Certified Action of the City of Raleigh Planning Commission

Case File / Name: SP-33-13 / Holly Hill New Inpatient Hospital

Nature of Case: Construction of a 53,645 square foot psychiatric hospital on an 18.3 acre site zoned Office & Institutional-2, outside the city limits.

Site Plan

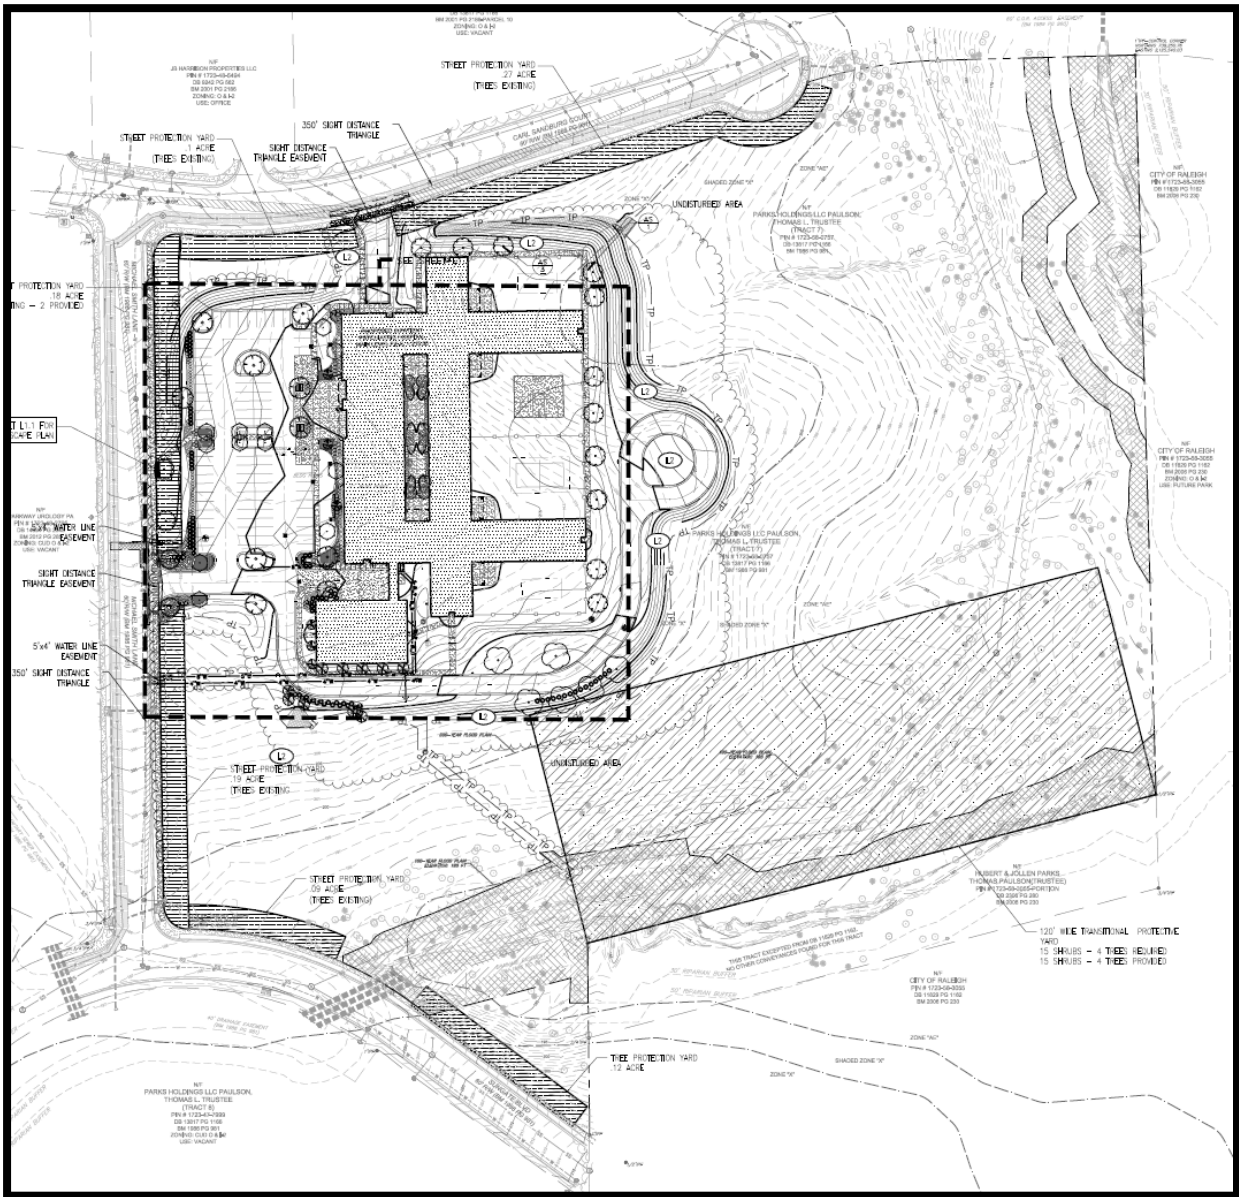
| Comment | Response |
|---|--|
| <p>Access to the service area should be narrowed to one lane with additional planting areas used to further screen the service area. Definition, articulation and relief should be added to the façade of the gym closest to Michael Smith Lane.</p> | <p>The drive to the service area has been narrowed to provide additional landscaped areas to aide in the screening of this area. The design of the façade of the gym will be reviewed and revised to add definition, articulation and relief to the building where possible based on design and cost considerations</p> |
| <p>The addition of wood elements and canopies to the gym façade as well as the ambulance entry in keeping with the main entry of the facility.</p> | <p>The design of canopies and facades will be reviewed and reviewed to add definition, articulation and relief to the building where possible based on design and cost considerations</p> |
| <p>Red Maples and Sugar Maples should not be used in parking lot islands. The Commission suggests addition of trees adjacent to the building and outside of play areas should be considered to provide shade, soften the façade and integrate the building with the surrounding landscape. Recommend planting of steep slopes rather than lawn.</p> | <p>Willow Oaks replaced the Red Maples in the parking lot Trees cannot be placed in play areas due to risk to patients.</p> |
| <p>The Commission recommends the addition of landscaped areas closest to the building entrance, such as the softening of the patio area, the addition of landscape islands in the parking lot closest to the entrance, and the shifting of parking spaces closest to the building entrance to accommodate additional landscaped areas.</p> | <p>The parking area in front of the main entrance to the building has been revised to provide a drop-off for patients and visitors as well as provide landscape areas.</p> |
